# **Appendix M**

# Responses to Comments

This appendix to the Final Environmental Impact Report (EIR) for the Olive Park Apartments Project (project) includes a copy of all comment letters that were submitted regarding the Draft EIR (Draft EIR), along with responses to comments in accordance with California Environmental Quality Act (CEQA) Guidelines Section 15088. The 45-day review period for the Draft EIR began on October 25, 2024, and ended on December 9, 2024.

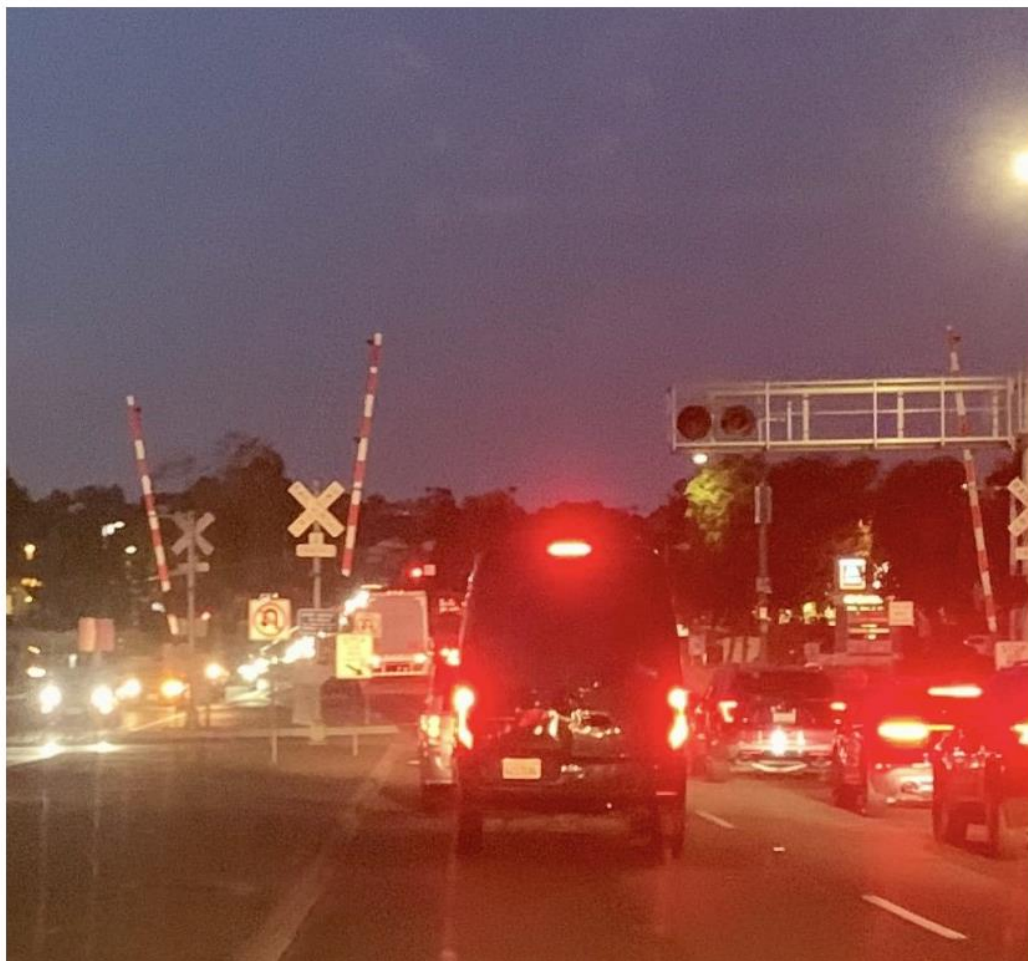
I-14-3  
Cont.

I-14-3  
Cont.

I-14-3  
Cont.

I-14-3  
Cont.
